Overview

This document explains an error and workaround for the fan interface of PicoZed SDR FMC Carriers (AES-PZSDRCC-FMC-G). This pertains to Rev B and Rev C FMC Carriers.

PicoZed SDR FMC Carrier – Fan Circuit Update v1.0

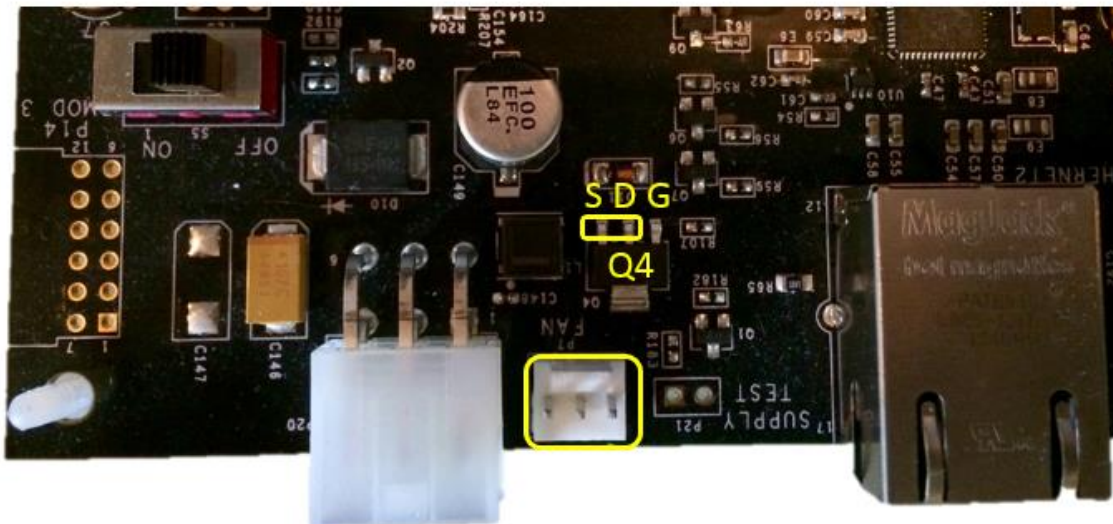
The FET (Q4) used to power the fan plug (P7) on the FMC Carrier will not turn on with standard 1.8V logic. In addition, the fan plug placement was rotated 180 degrees resulting in improper electrical connection. No circuit damage will occur if you plug a fan in, however the fan circuit will not work.

Shorting the drain (D) and source (S) pins of the FET (Q4) will connect 5V DC to the fan plug. See picture below to identify the drain and source pins. You will not be able to PWM the fan. Instead, whenever the fan is plugged in it will be on.

The fan plug (P7) is also highlighted below. A small, flathead screwdriver can be used to lift the white plastic shrouded key off of the 3-pin fan plug. Rotate it 180 degrees and push it back onto the pins as shown below.

New Rev C carriers use a different FET which operates with 1.8V logic on the gate. The orientation of the fan plug was also corrected.

If your carrier has the fan plug oriented as shown in the picture above, then the FET (Q4) has already been replaced with one that operates with logic signals down to 1.8V. No changes are required. You may enable the fan from the Zynq PL of your PicoZed SDR SOM.
